# PD 3

DEPARTMENT OF PLANNING AND DEVELOPMENT  
CITY OF CHICAGO

**Re: Minor change to PD 3, Subarea E, Connector between Galter and Feinberg Pavilions**

# PD 3 ELEVATIONS - PARTIAL AT GALTER PAVILION

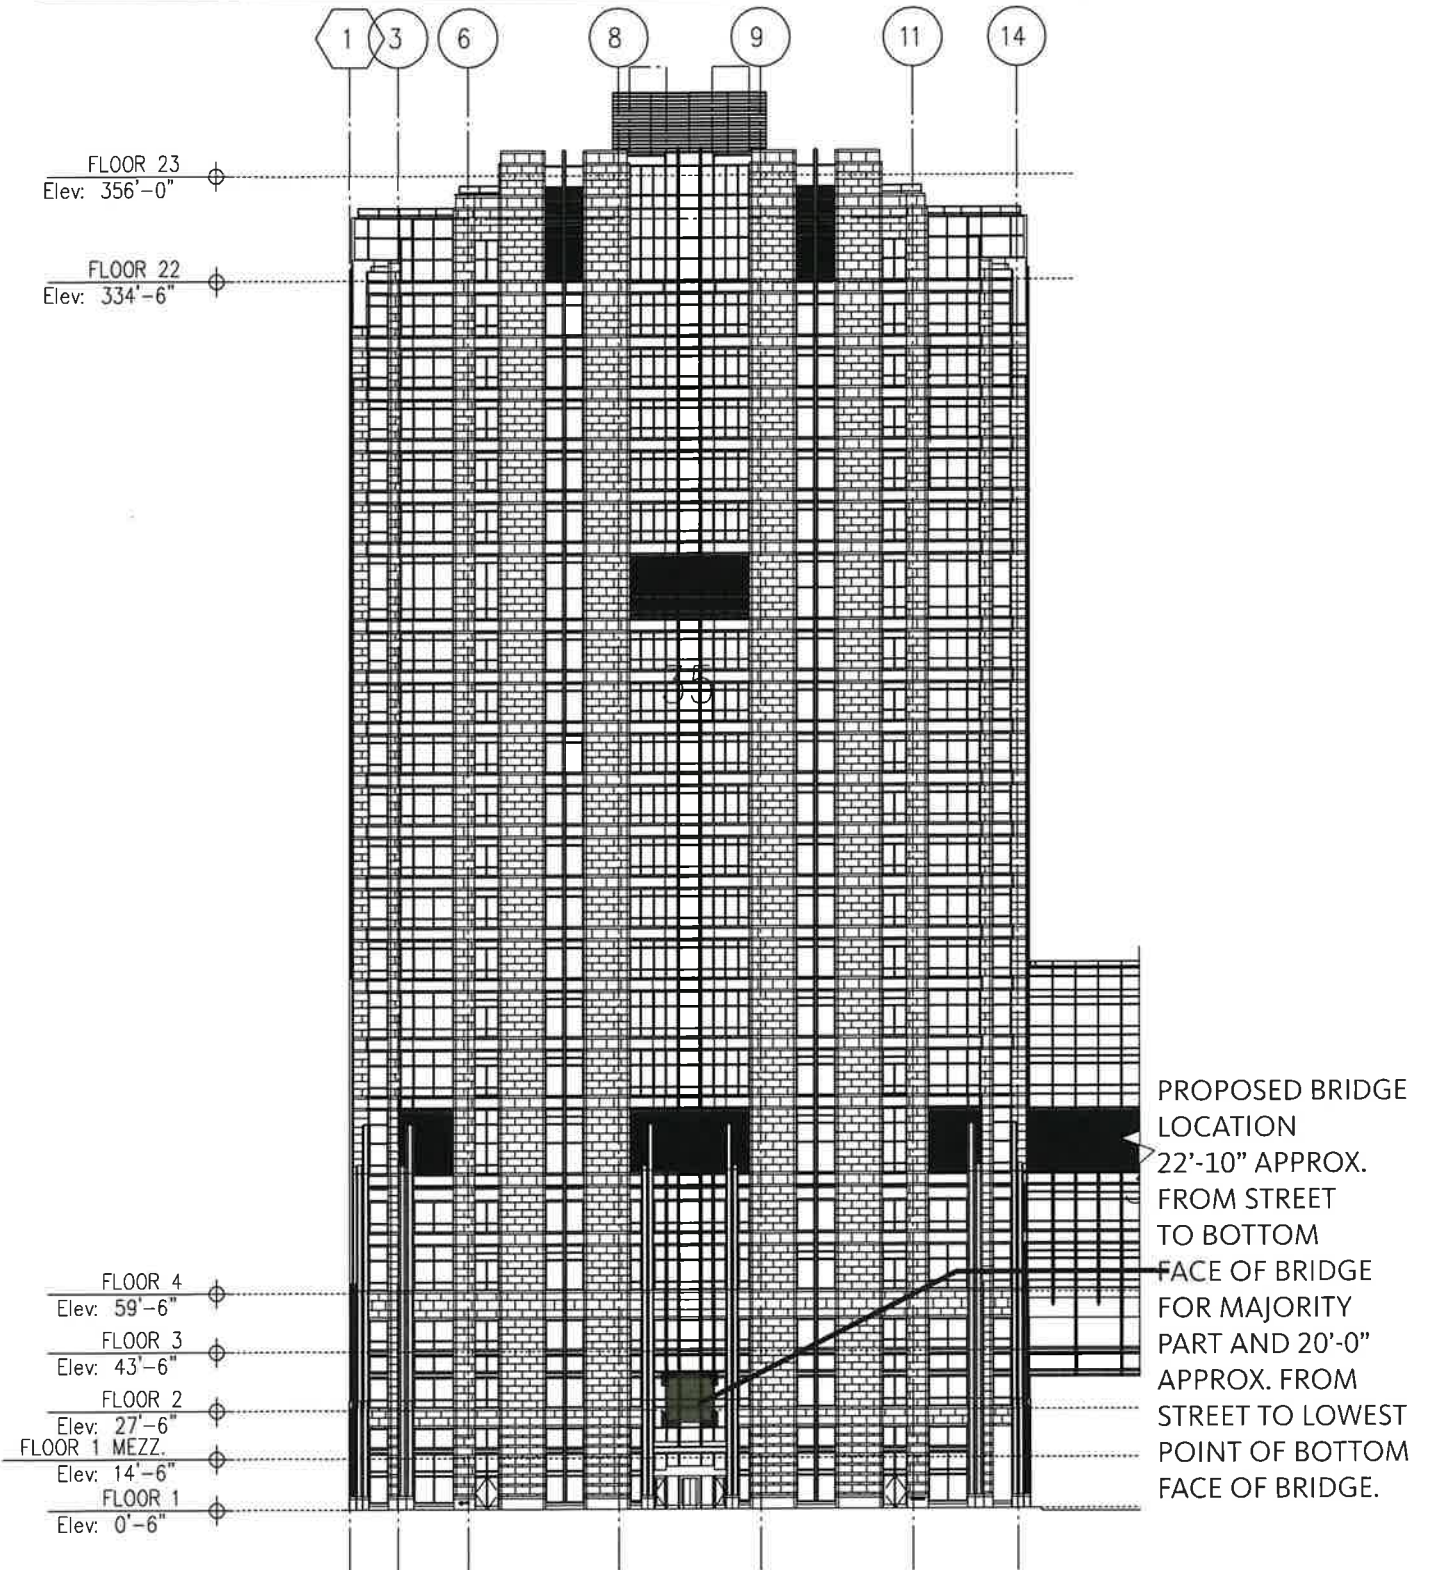
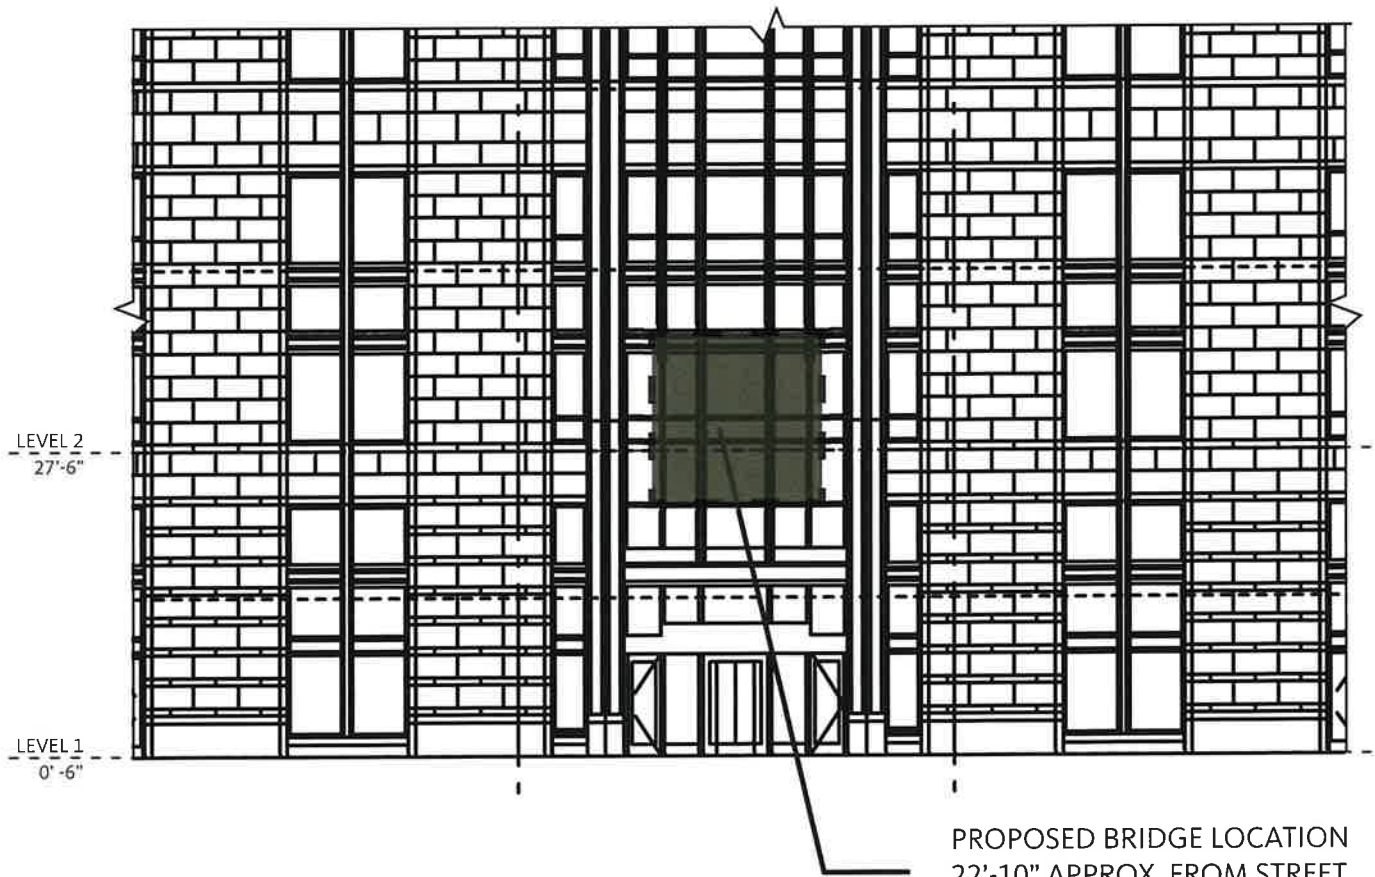
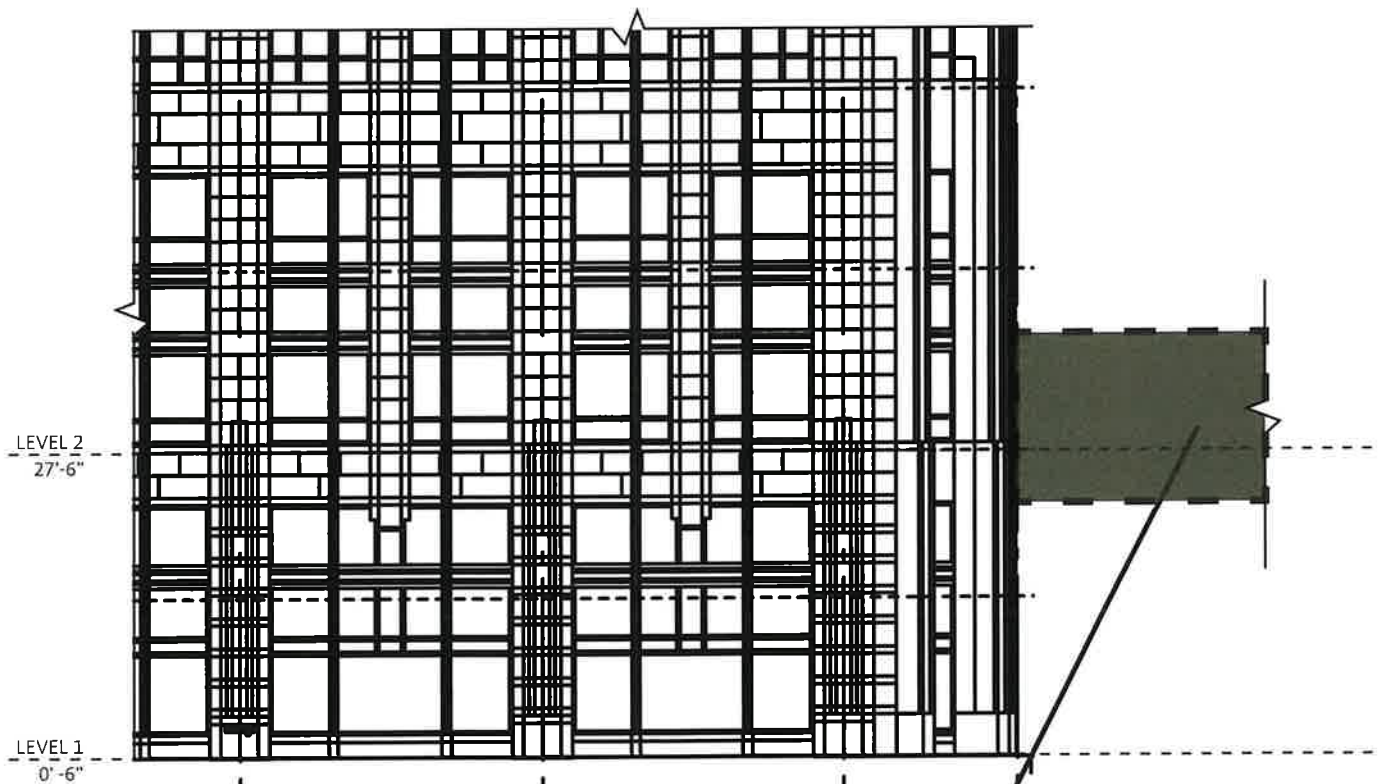
Northwestern proposes to construct a pedestrian bridge (“Bridge”) over East Erie Street, connecting Galter, with the medical service floors located at 633 N. St. Clair (“PD 468”). Northwestern is also in the process of finalizing an Easement of Air Rights Agreement (Application No. 10-02-23-4065) over East Erie Street with the City of Chicago for the Bridge. The Bridge is necessary to provide passage of Northwestern’s patients, medical providers and staff between Galter and the medical offices located within PD 468. After hours, access to the Bridge will be permitted via card readers only. A 360-degree security camera will be installed on the center of Bridge, license plate reader cameras will be installed on the underside of the Bridge and 180-degree security camera will be installed in the vestibule of both Galter and 633 N. St. Clair.

PROPOSED BRIDGE LOCATION  
22'-10" APPROX. FROM STREET  
TO BOTTOM FACE OF BRIDGE  
FOR MAJORITY PART AND 20'-  
0" APPROX. FROM STREET TO  
LOWEST POINT OF BOTTOM  
FACE OF BRIDGE.

1 12TH FLOOR PLAN - CONNECTOR  
11/01/2011

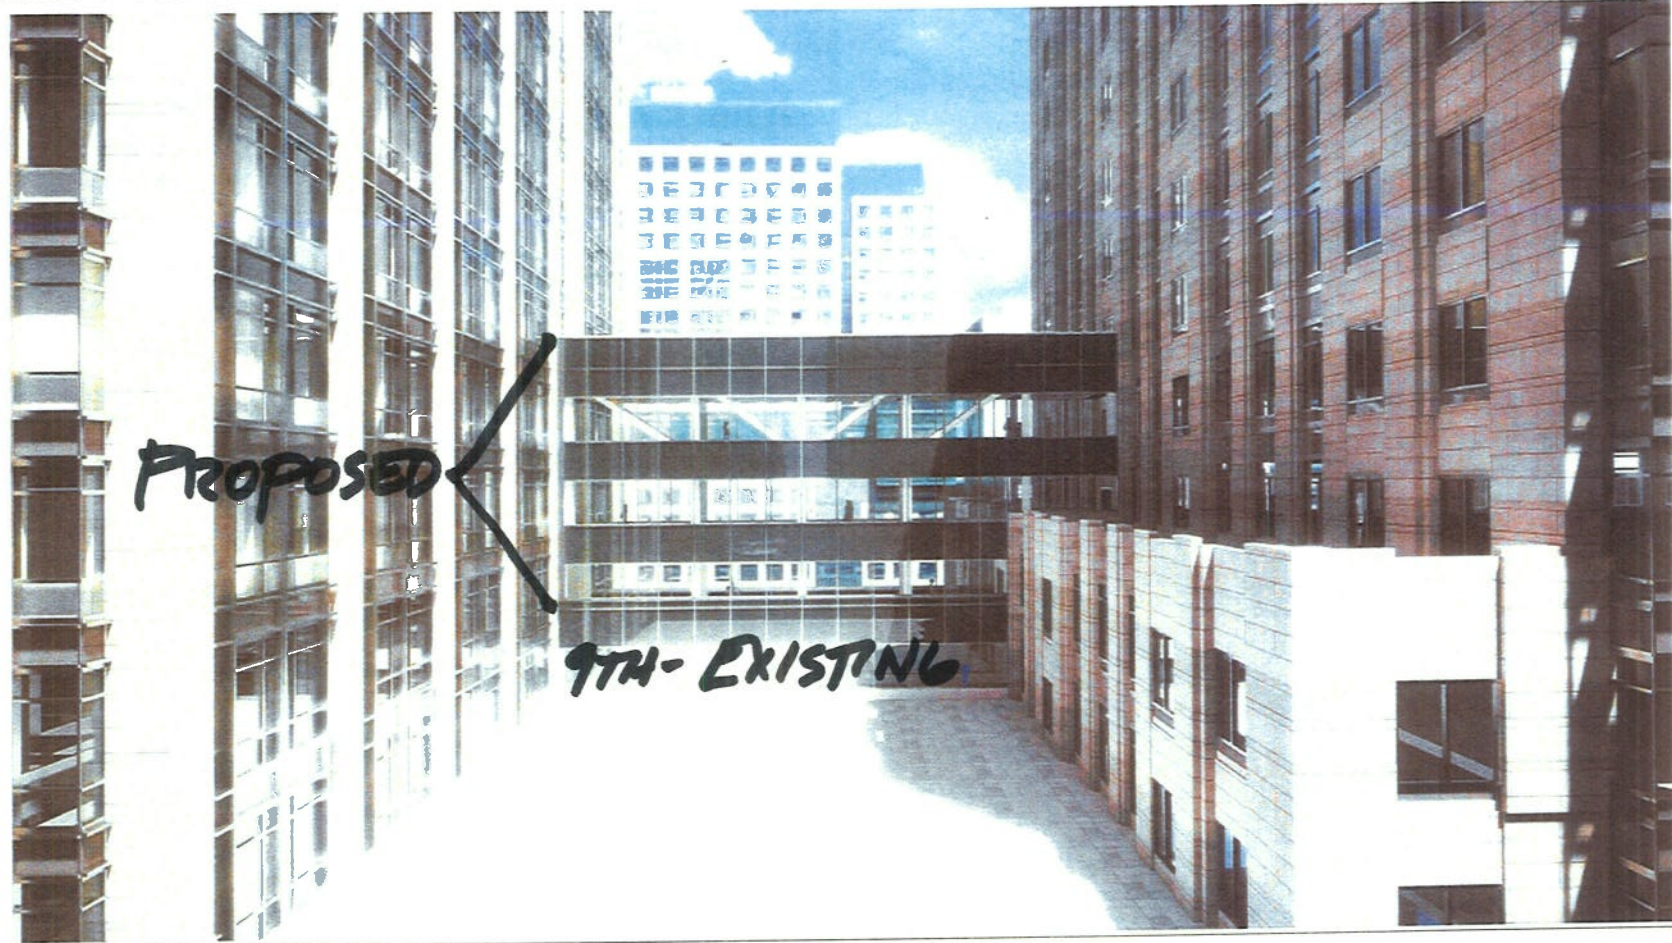
Your client, Northwestern Memorial Hospital, along with the consent of Northwestern University, the zoning control party of PD 3, is seeking a minor change to allow for a rooftop connector between Galter and Feinberg Pavilions at 251 E. Huron St. There is an existing 9<sup>th</sup> floor connector between the two buildings and the proposed addition will sit atop it and consist of an approximately 15' wide by 96' long connector at the 10<sup>th</sup> thru 12<sup>th</sup> floors. The Hospital is converting medical office space in the Galter Pavilion into hospital space and the connectors will be used to safely transport patients, supplies, equipment, and food. There is no potential to add elevators to the Galter Pavilion. The connector will be set back from Huron St. approximately 100 feet, and 140 feet from Erie St., and therefore, will not be visible from either street. The cladding of the 4,900 square foot addition will match the size and finish of the existing 9<sup>th</sup> floor connector and it will align with the existing dimensional layout and coursing, as shown on the attached plans, elevations, and renderings.

**Re: REVISED Minor change for PD No. 3, Sub area E, Northwestern Memorial Hospital's Galter Pavilion, 201 E. Huron St., Entryway elimination**

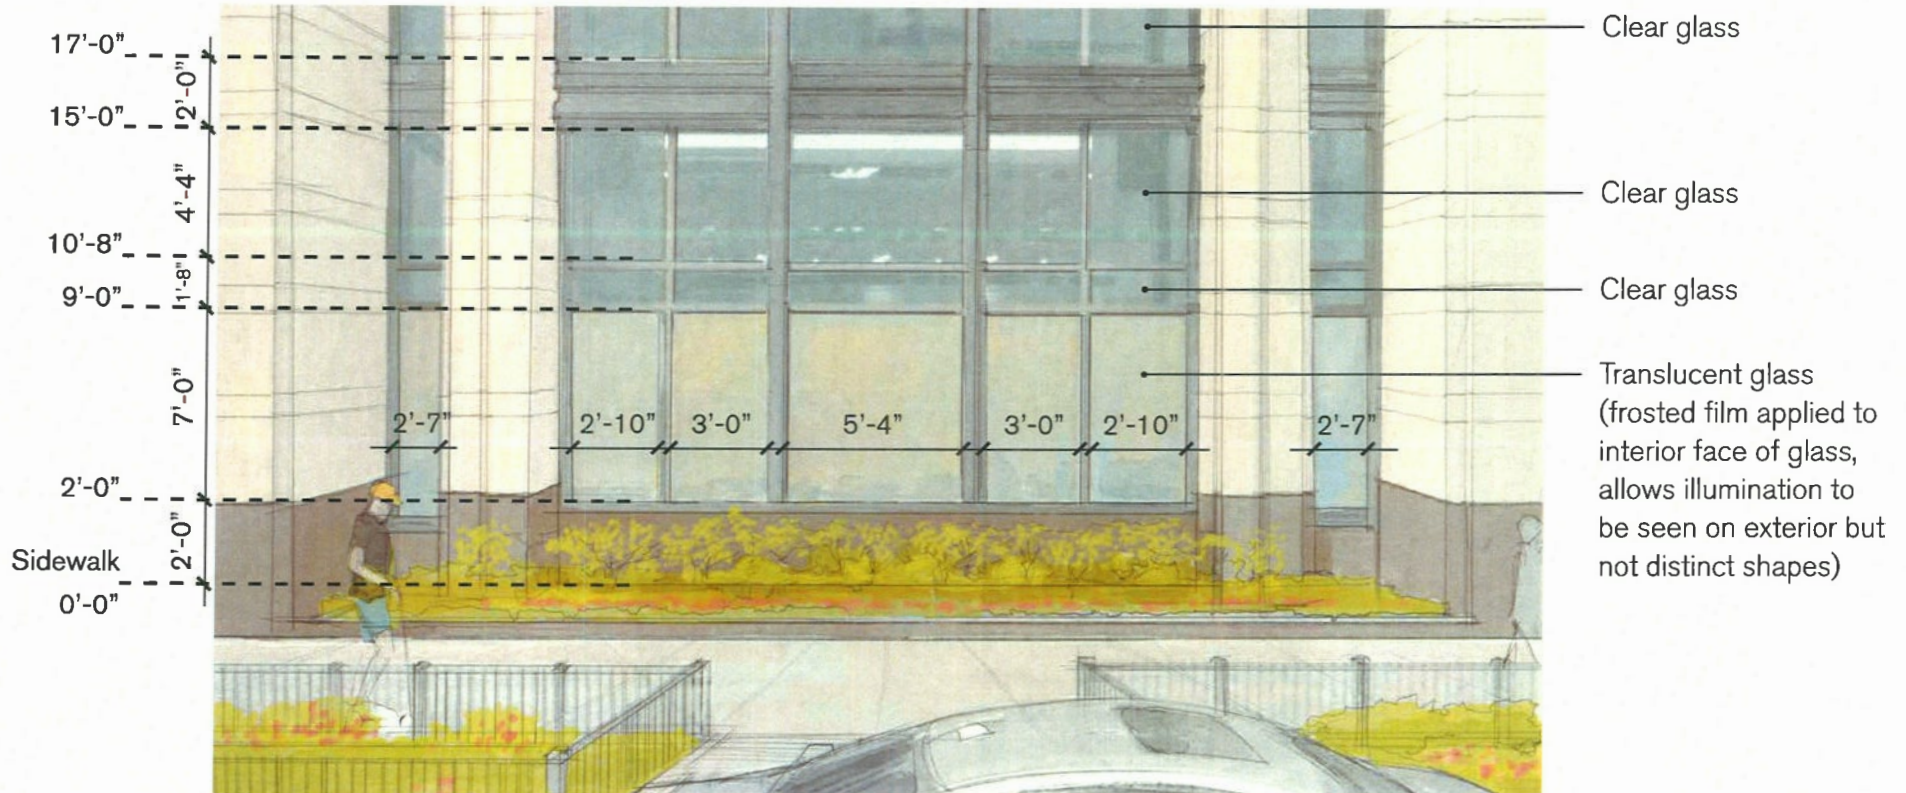
On November 15, 2019, Northwestern Memorial Hospital's ("NMH") minor change request to enclose the Huron St. entrance to the Galter Pavilion at 201 E. Huron St. with a combination of clear and translucent glass storefront system was denied. While we still would prefer the replacement of an active, clear glass entryway with a fully clear glass storefront, we also understand the hospital's security and safety concerns. Additionally, NMH has a mixture of clear, translucent, and spandrel glass on this and adjacent buildings.

Therefore, the Department of Planning and Development has determined that allowing the opening to be replaced with a combination of translucent glass with clear glass above, and landscaped as shown on the attached rendering, will not create an adverse impact on the Planned Development or surrounding neighborhood, will not result in an increase in the bulk or density, and will not change the character of the development, and therefore, would constitute a minor change.

**Re: Minor change denial for PD No. 3, Sub area E, Northwestern Memorial Hospital's Galter Pavilion, 201 E. Huron St., Entryway elimination**

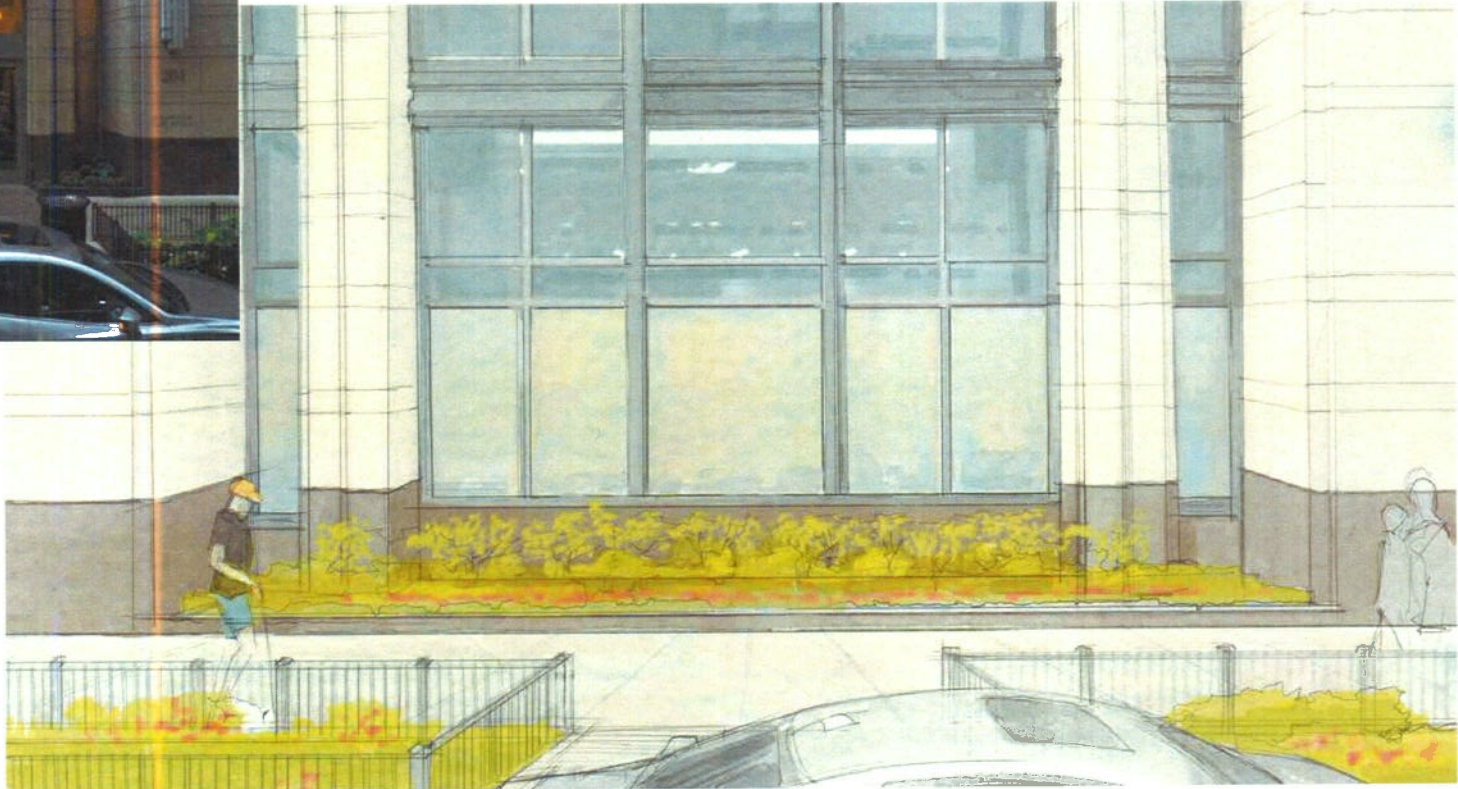
You are requesting on behalf of your client, Northwestern Memorial Hospital ("NMH"), a minor change to enclose the Huron St. entrance to the Galter Pavilion at 201 E. Huron St. As shown on the attached drawing, a new fixed, glass storefront system would be installed and as a result, approximately 15 square feet of new interior space would be added. The new space would provide for a central wheelchair staging area and relocated customer service desk. The clear glass entryway would be replaced with a combination of fixed, opaque glass and clear glass.

With regard to your request, we do not support the replacement of an active, clear glass entryway with a partially obscured storefront along Huron St. While understanding NMH proposes to use this space for wheelchair storage, we encourage the use of clear glass for the entire opening so that the public way remains as active as possible. Additionally, according to the photo submitted with your request, clear glass, rather than frosted glass, currently exists in the storefront systems on either side of the existing entryway.

Accordingly, pursuant to the authority granted by the Chicago Zoning Ordinance and Institutional Planned Development No. 3, I hereby deny the proposed replacement of the existing entryway with the proposed frosted and clear glass configuration as shown on the attached.
